SECTION 00 91 01

**ADDENDUM NO. 1**

This document includes requirements that clarify or supersede portions of the Request for Proposal. This Addendum is a Contract Document.

**BUILDINGS 5 & 6 RENOVATIONS**  
 San Mateo County Community College District

PROJECT N  
SCALE 1/8" = 1'-0"  
THIRD FLOOR UPPER REFLECTED CEILING PLAN - ALTERNATE 9  
4

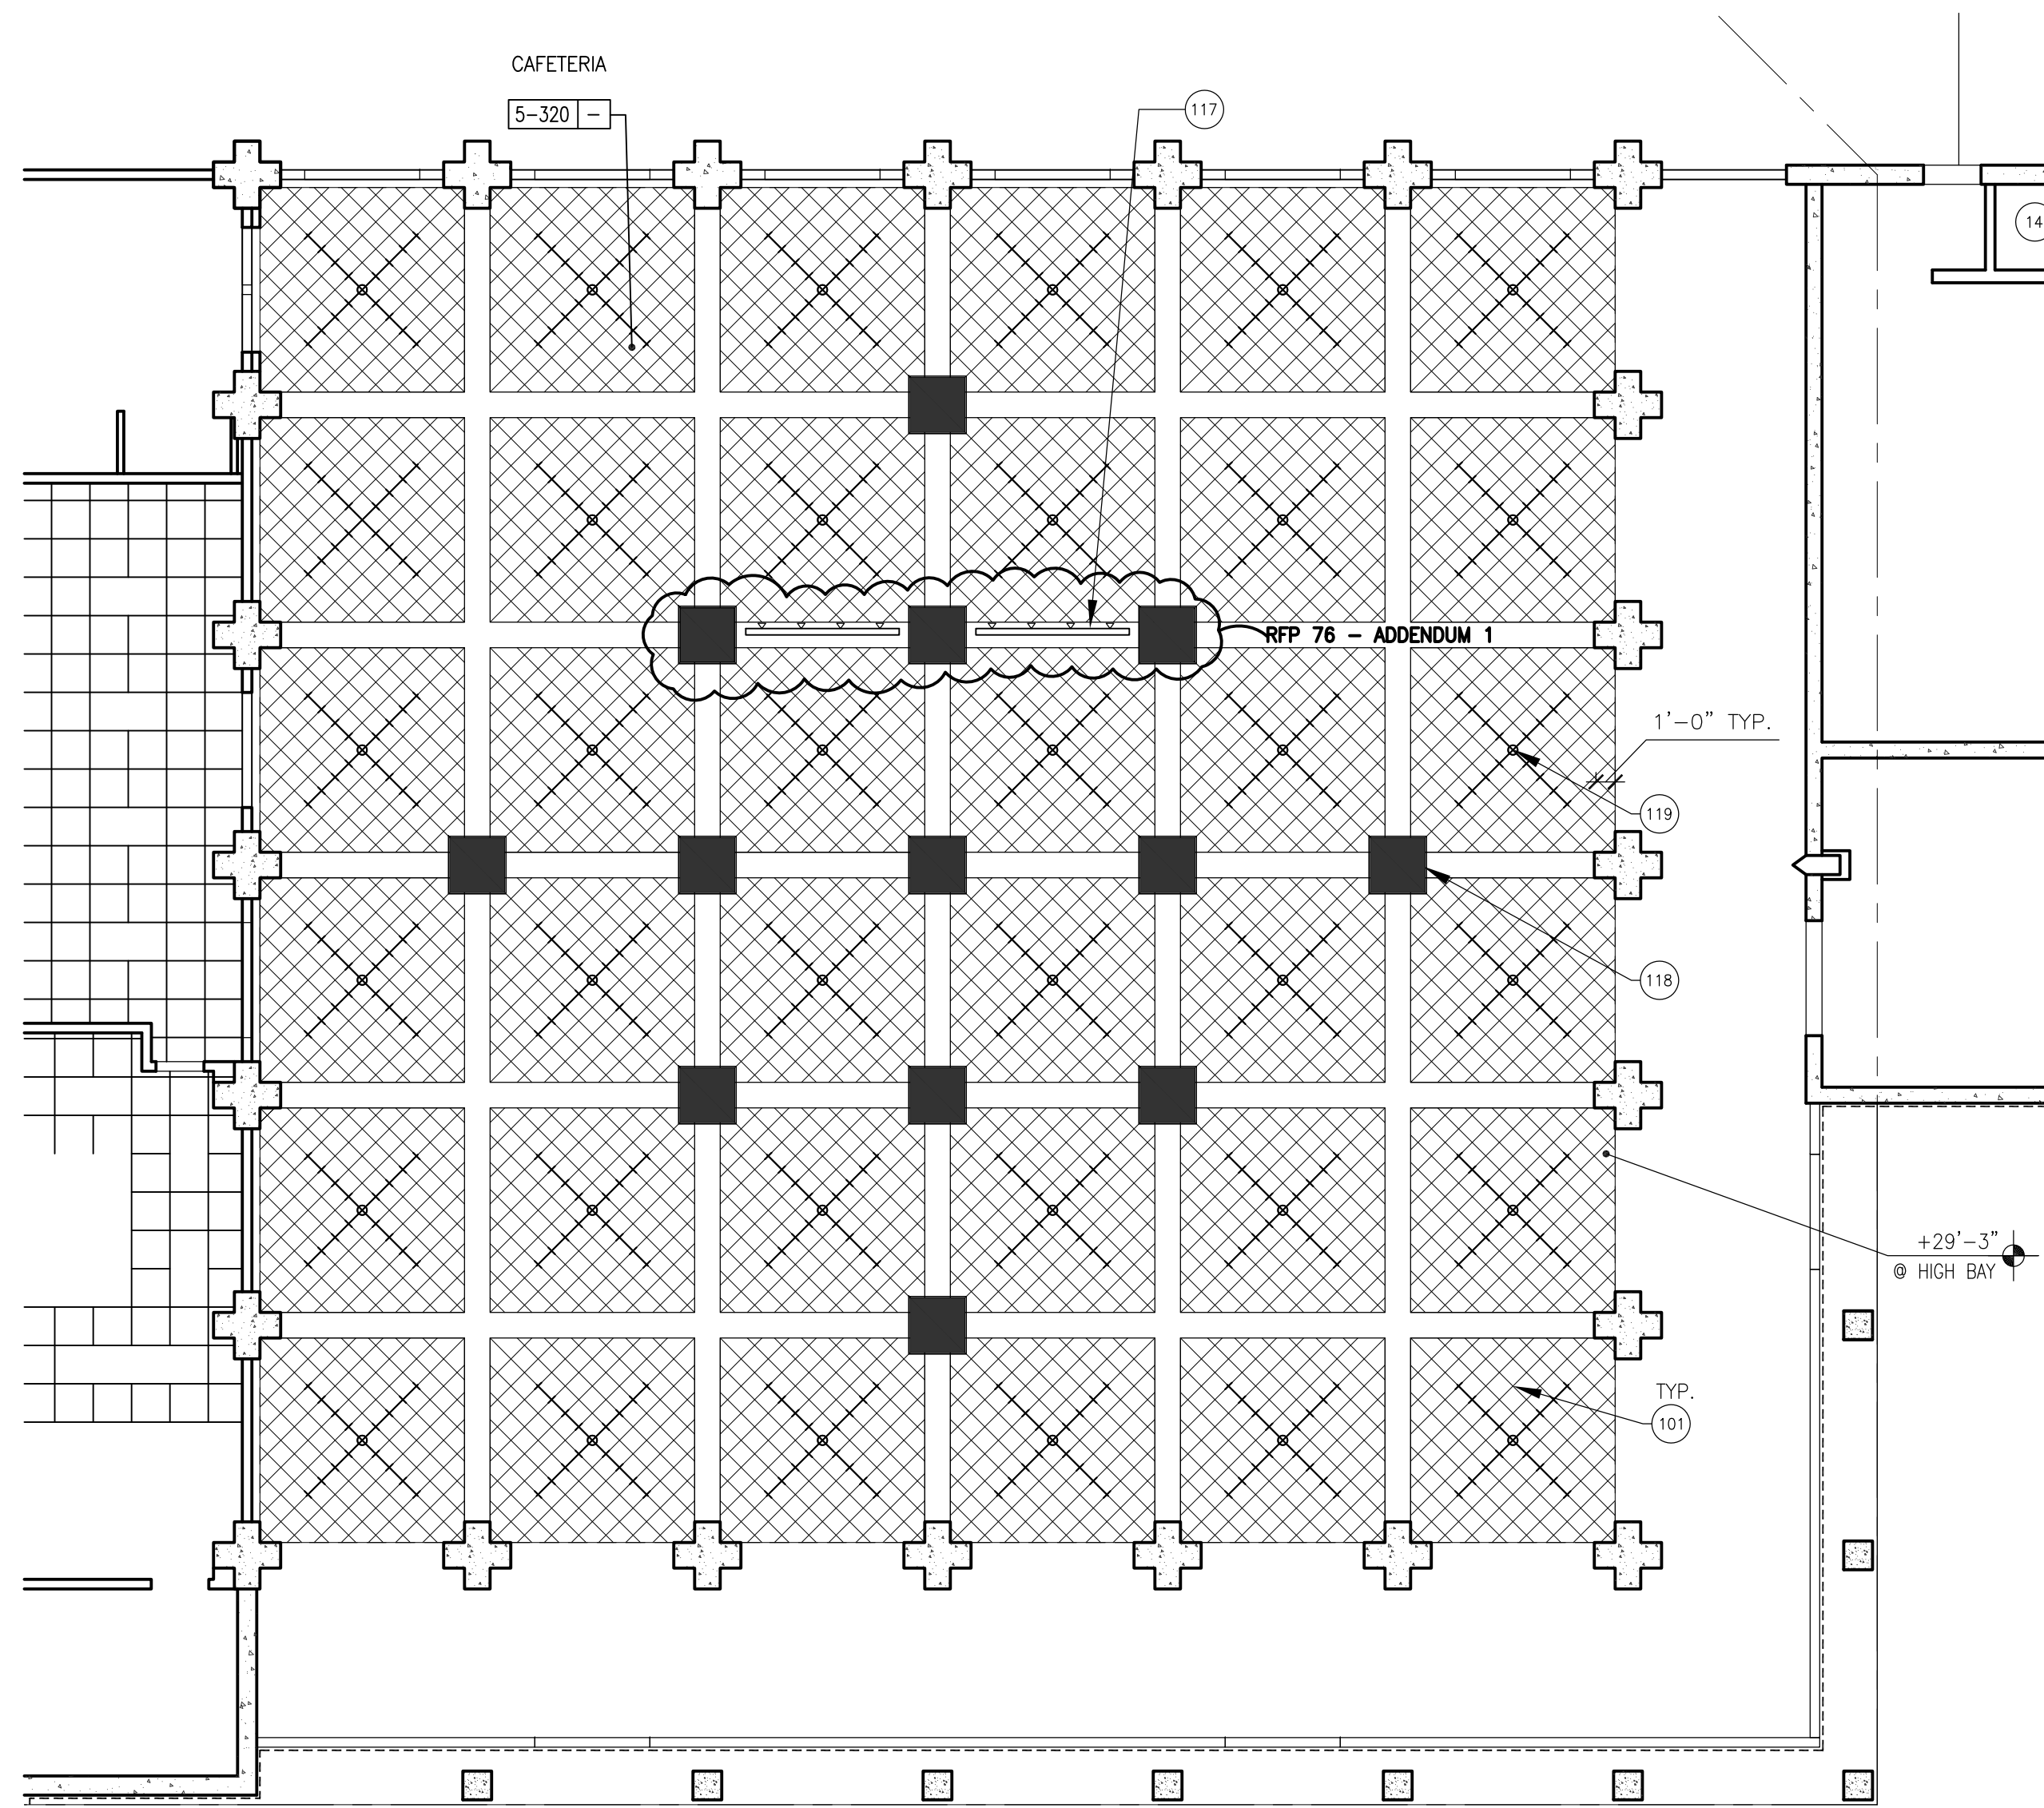
- 3. Drawing A3.34R – Third Floor Upper Reflected Ceiling Plan – Add Alternates.
  - A. Modified drawing as shown on attached revised Drawing A3.34R:
    - 1. Removed Add Alternate #10 from list of Add Alternates.

- 2. Replaced Stage Lighting Remote Lowering System with Fixed Stage Track Lighting for Detail 2, 3 and 4.
    - 3. Added Sheet Note 117 for Stage Lighting at bottom (e) coffered ceiling beam.

Date: 04/22/11  
Scale: AS NOTED  
Project Number: 07013  
Drawing Number: A8.6R

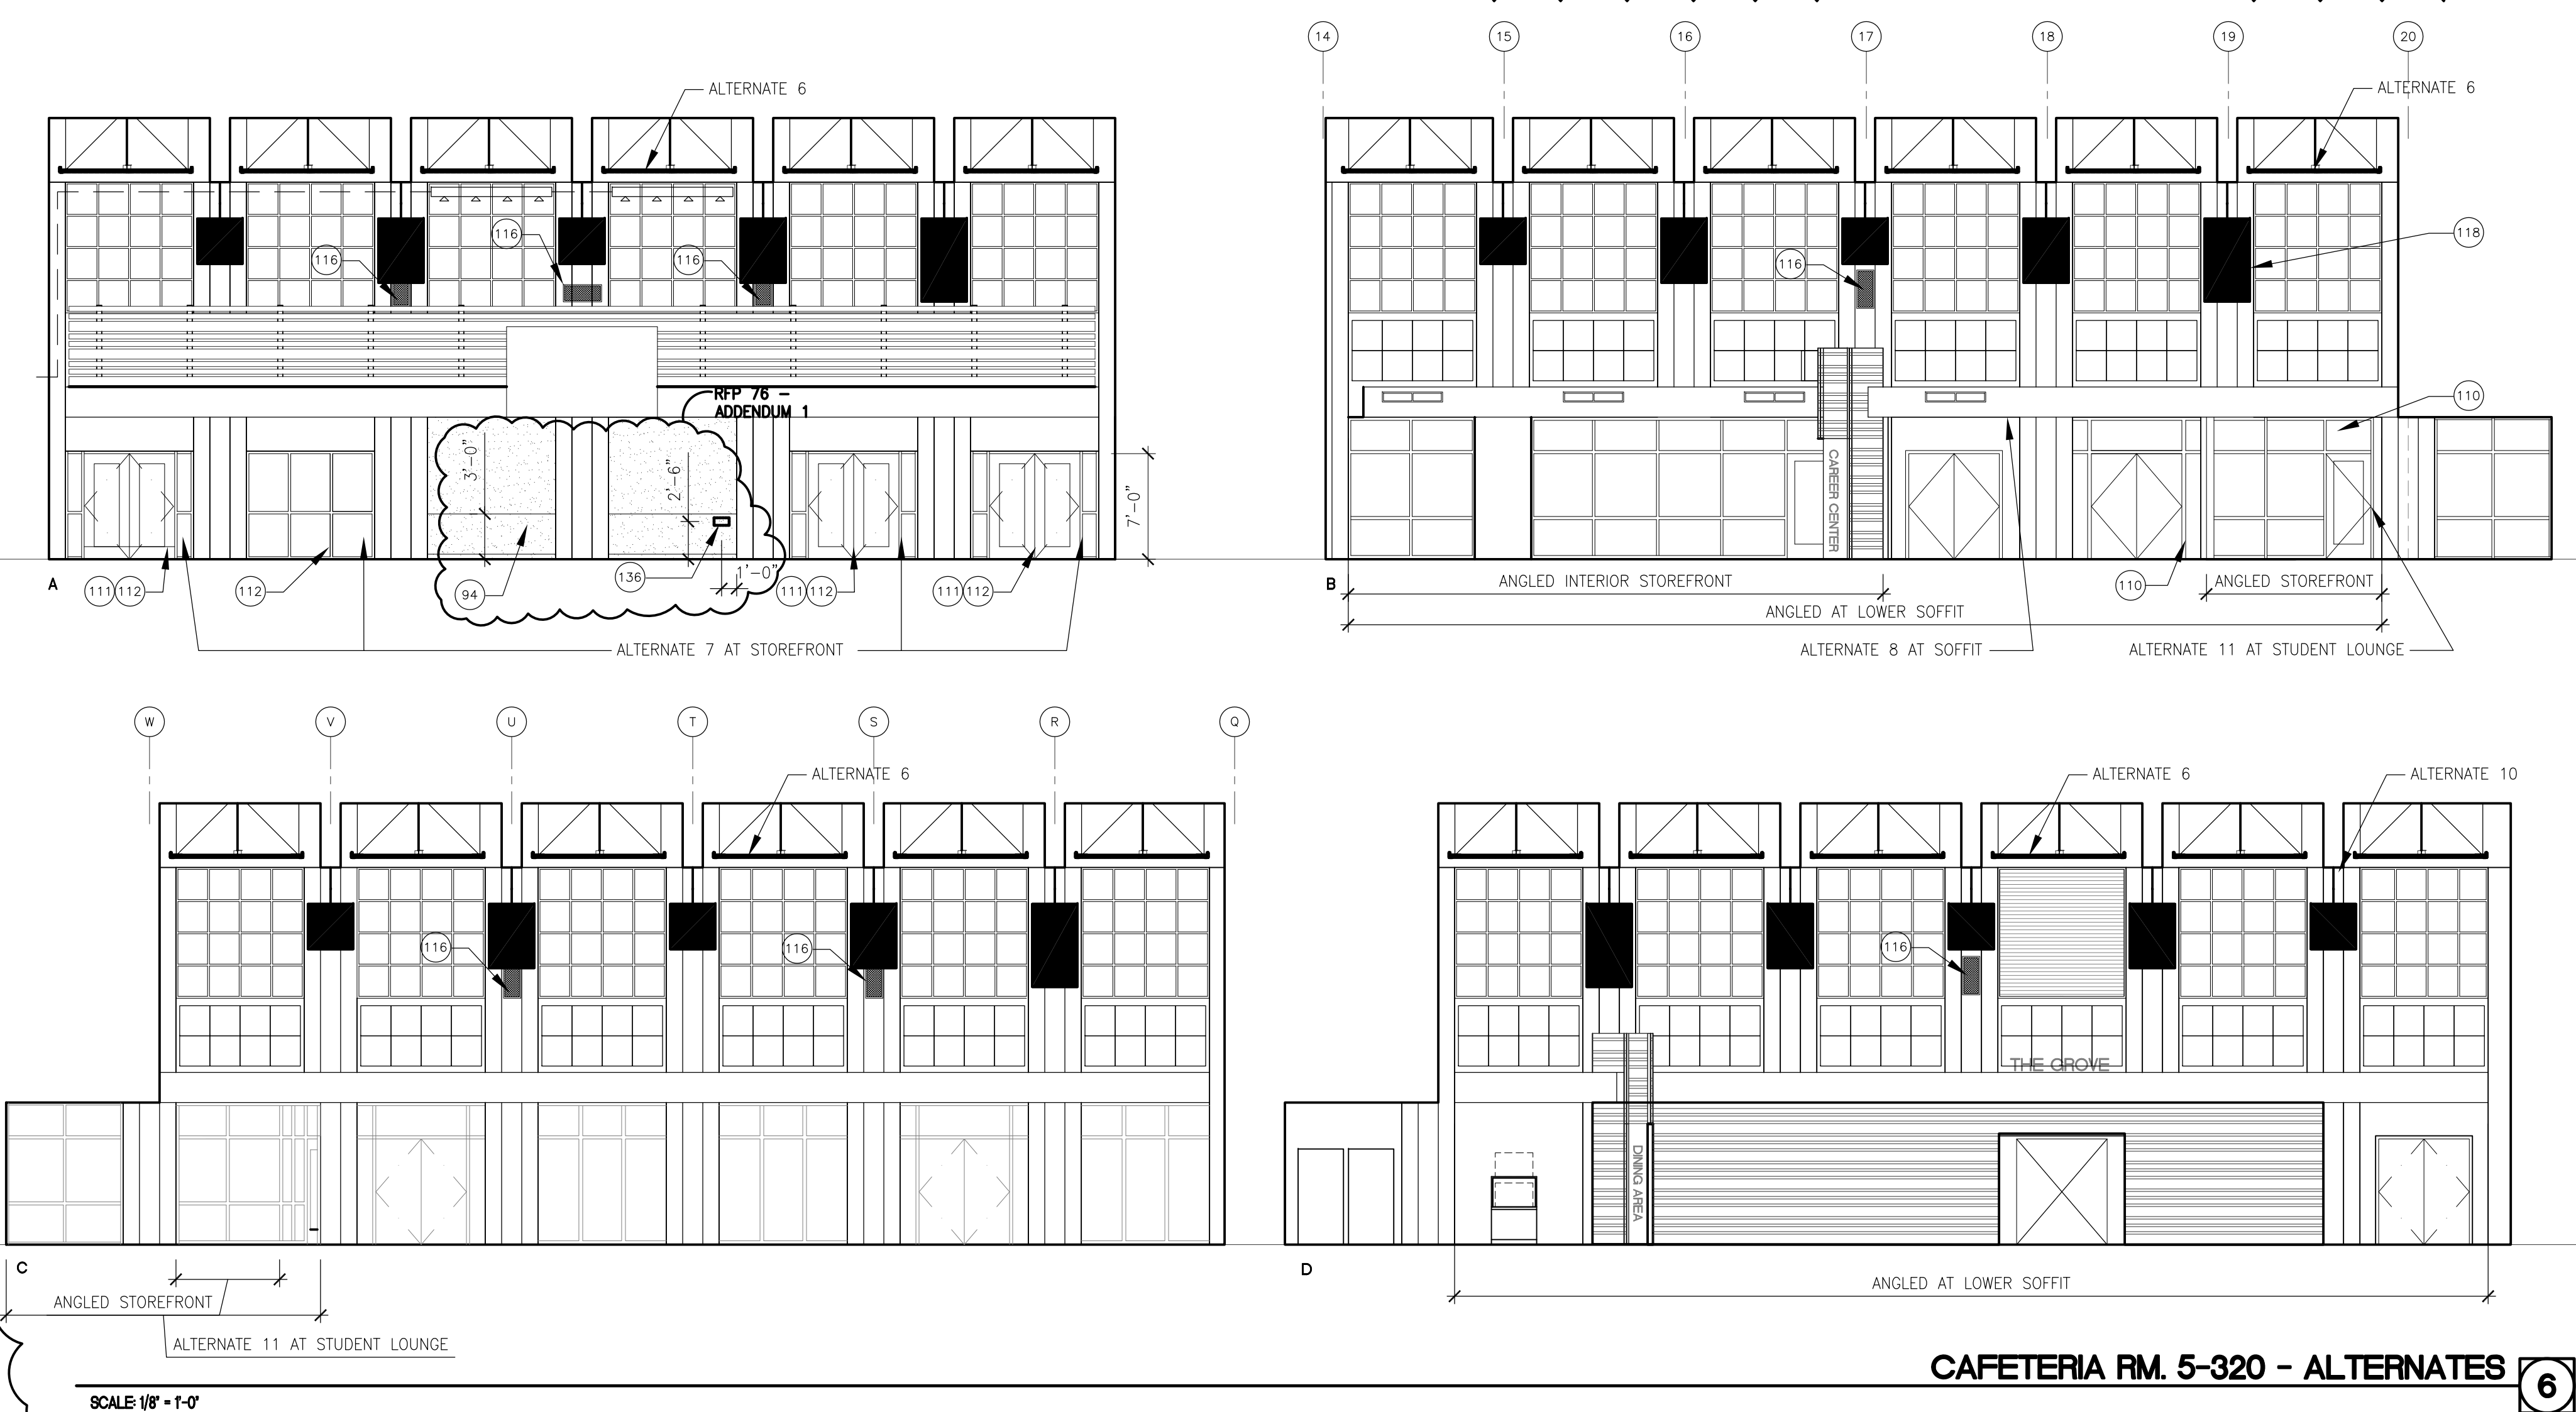
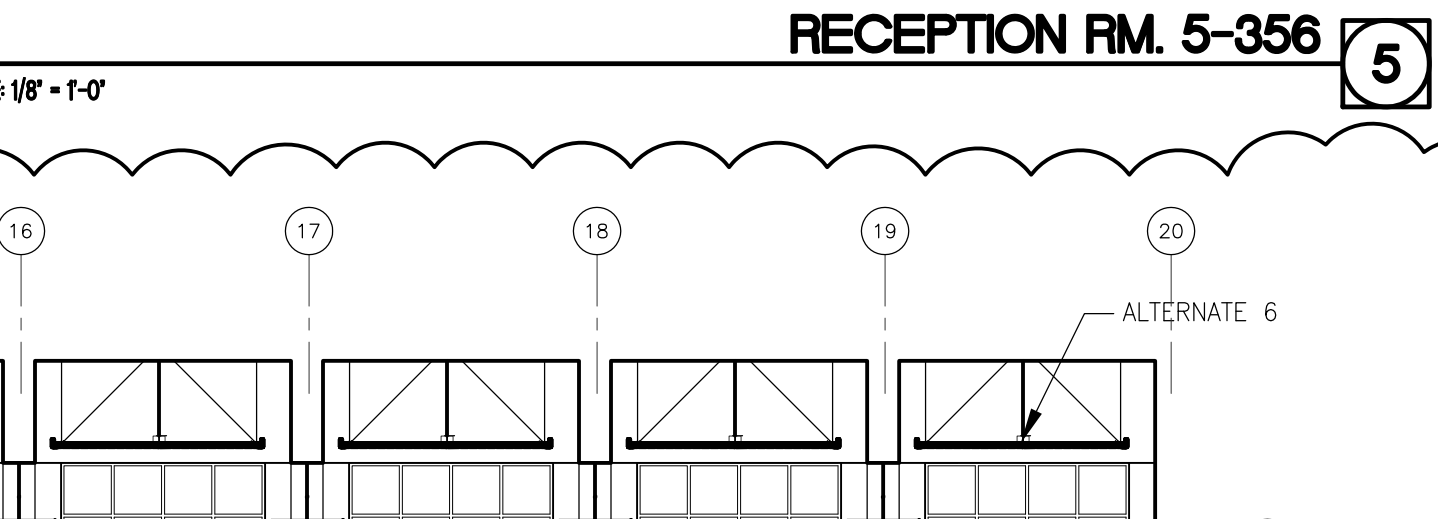
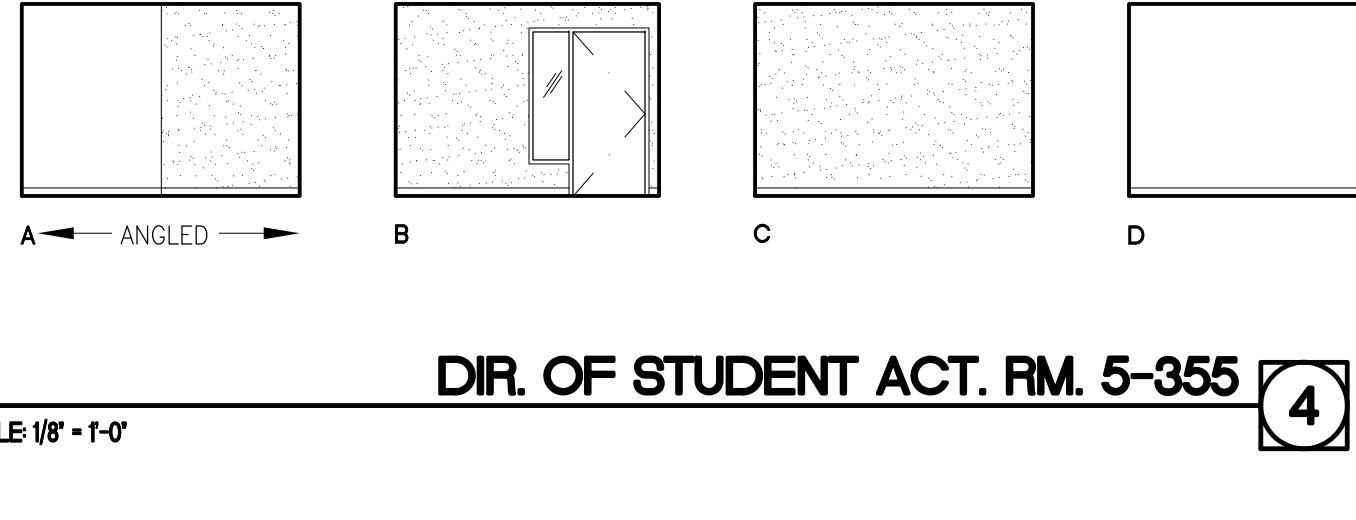
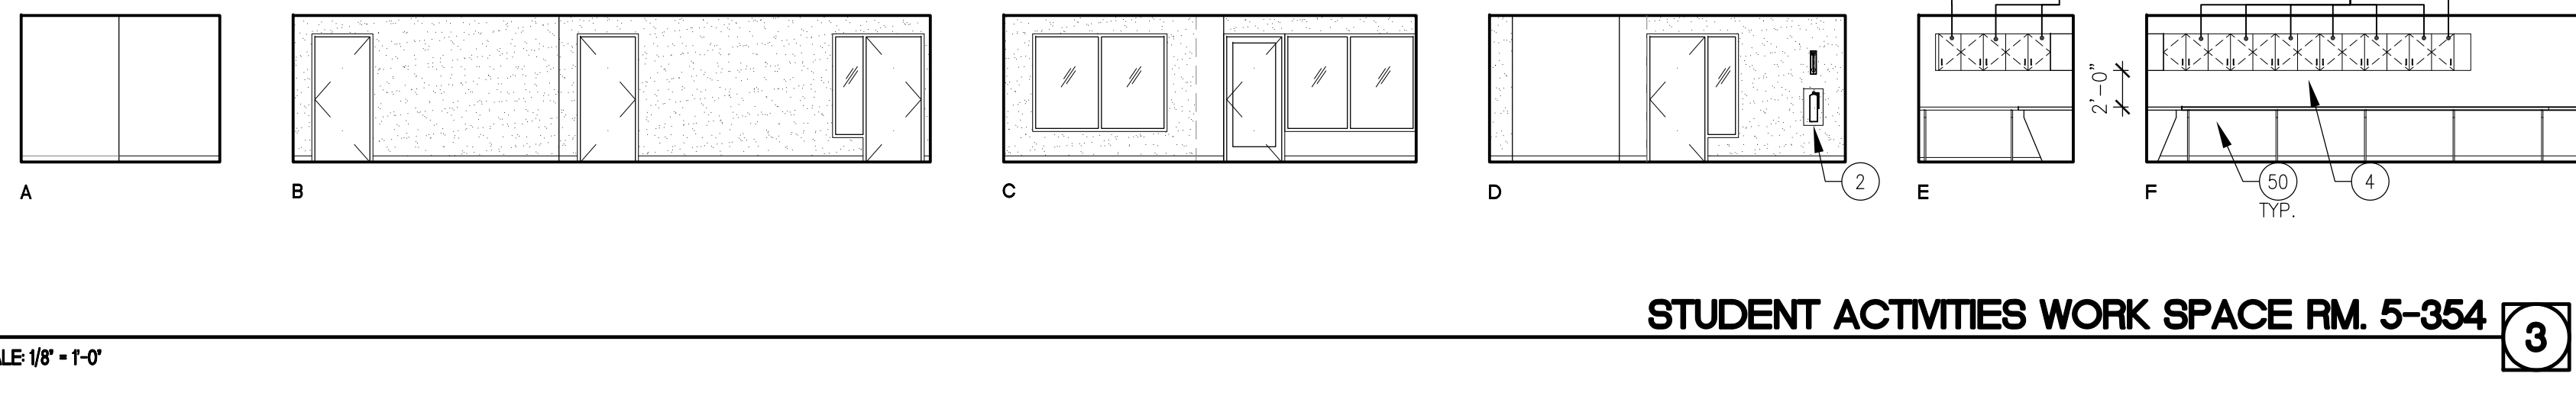
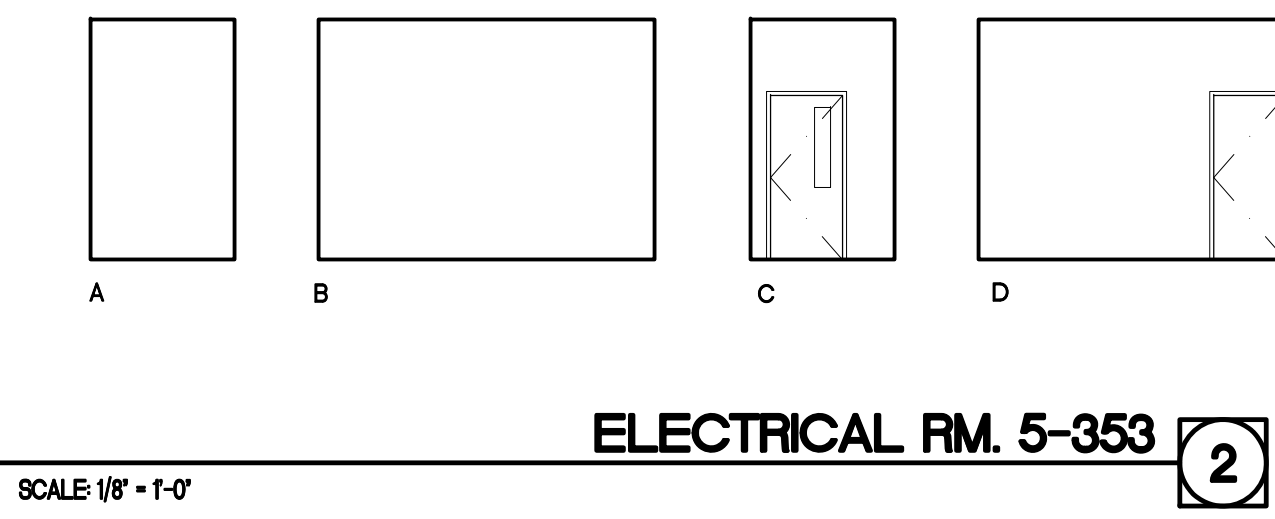
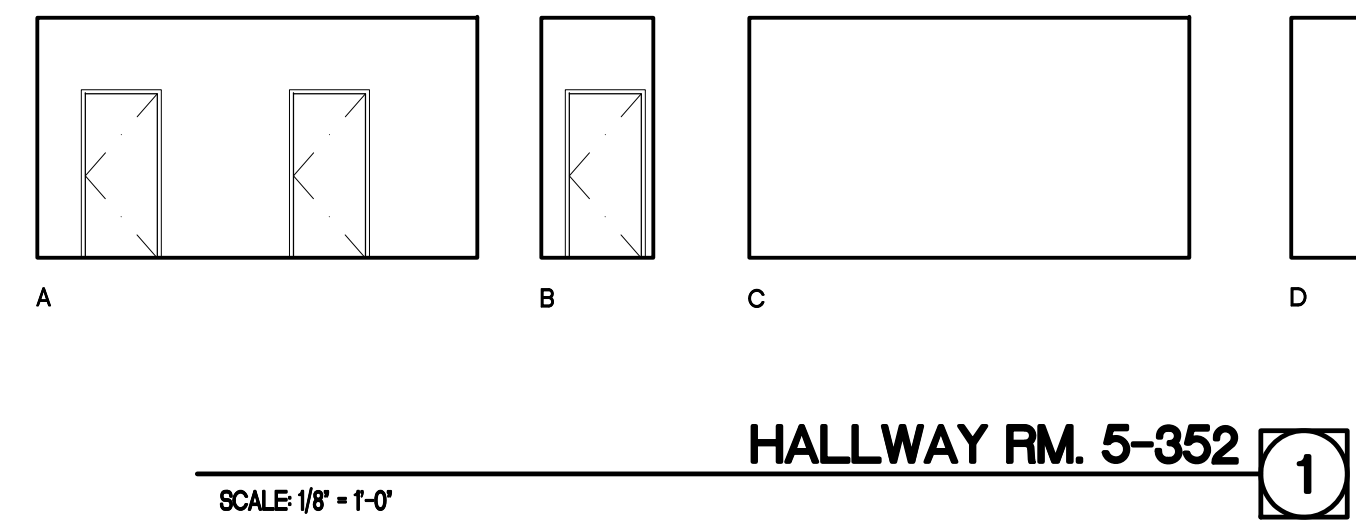
- 4. Add location of AV Patch Panel on Interior Elevation 6A.
    - 5. Delete Sheet Note 117.
- 5. Drawing A8.6R – Third Floor Interior Elevations - Alternates

- A. Modified drawing as shown on attached revised Drawing A8.5R:
    - 1. Added Sheet Note 116 for AV Speaker System.
    - 2. Added AV Speaker system and Sheet Note 116 symbol at each speaker location in Cafeteria Room 5-320.

- 3. Add Sheet Note 136 for AV Patch Panel
    - 4. Add location for AV Patch Panel on Interior Elevation 6A
    - 5. Delete Sheet Note 117.
- 6. Drawing A9.1R – Finish, Window Schedules.
